CONVAIR

COMMERCIAL CHANGE PROPOSAL

SPEC NO.: ZD-22-003

MODEL: (880) 22-2

CONVAILR 880 TRIPLE COACH SEAT

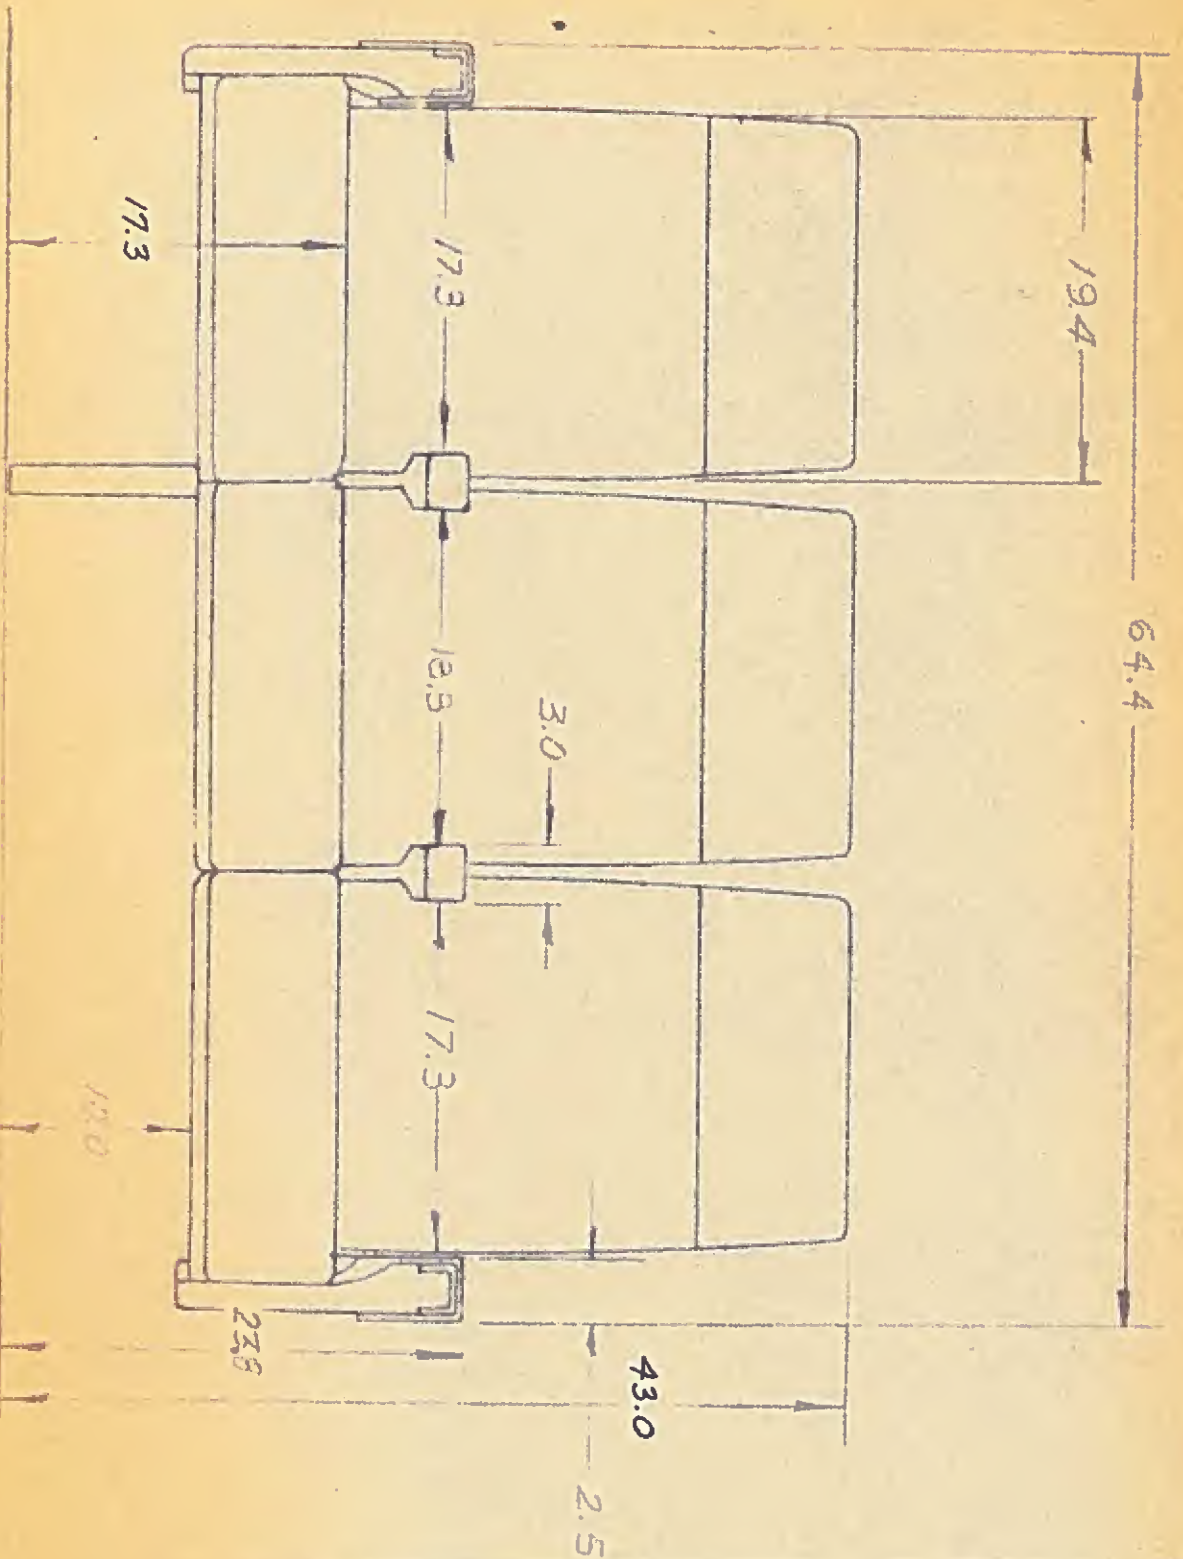
Item "A" in paragraph 3.19.1.1.6.2 of this proposal, will provide five plug-in trays for first six rows of Customer order per airplane. Five additional plug-in trays will be provided for 18 or more coach seat rows per airplane. Receptacles for plug-in trays shall be provided as loose equipment on all coach seats not having receptacles installed.

The following parameters shall be used in the coach seat design:

Enclosure: (A) One (1) copy of sketch of proposed Club Area Arrangement.

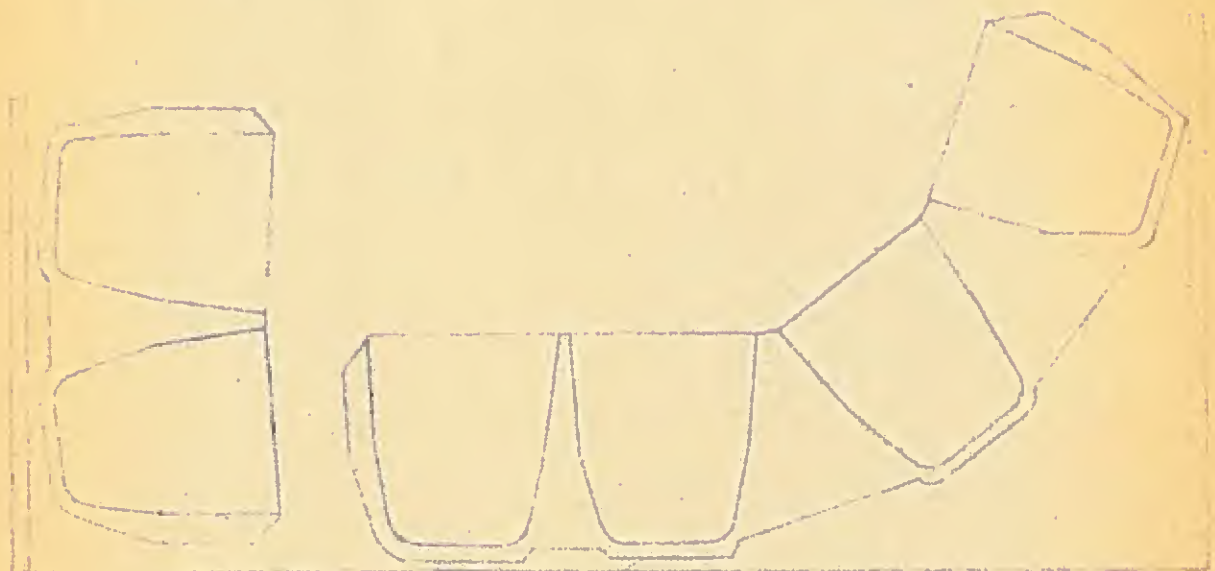
"The standard 84-passenger configuration (including 12 club area passengers) shall include full provisions to permit quick conversion to a full range of mixed class interiors utilizing the two coat compartments shown in Figure 1-3 as dividers. These coat compartments shall be designed to utilize the standard floor seat attach

points and thus may be placed in any of the rows between rows six and fifteen inclusive, excluding emergency hatch areas, in the main cabin section. Each of the 22 seat rows shall incorporate standard cabin windows, and each row aft of the club area shall have reading lights and individual air outlets for five abreast seating as shown in the coach configuration in Figure 1-3. All rows shall permit the installation of standard seats or coach seats. Provisions shall be made for installation of a left and right hand hat rack in the club area for use with four and five abreast seating arrangements."

FIGURE 3.12-5

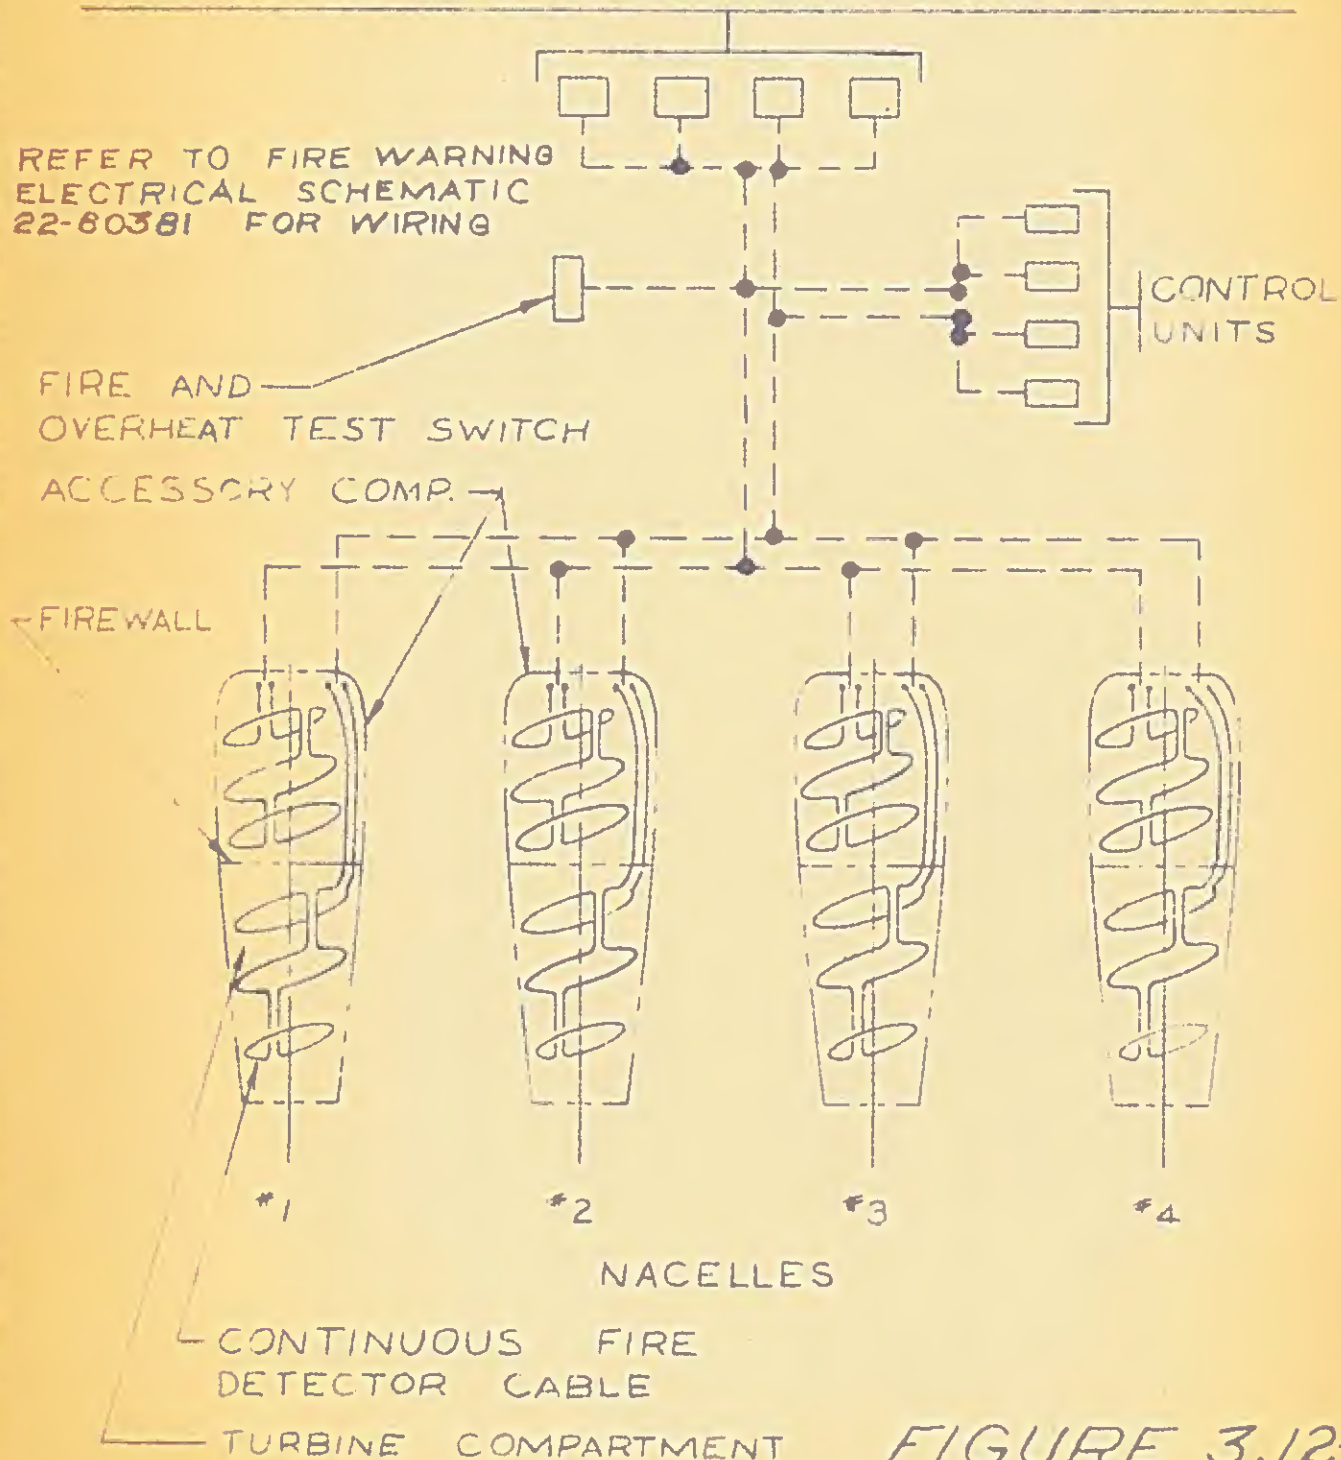
Enclosure (A): One (1) copy of Figure 3.12-5 FIRE DETECTOR SYSTEM, ENGINE NACELLES (Revised 1-23-58).
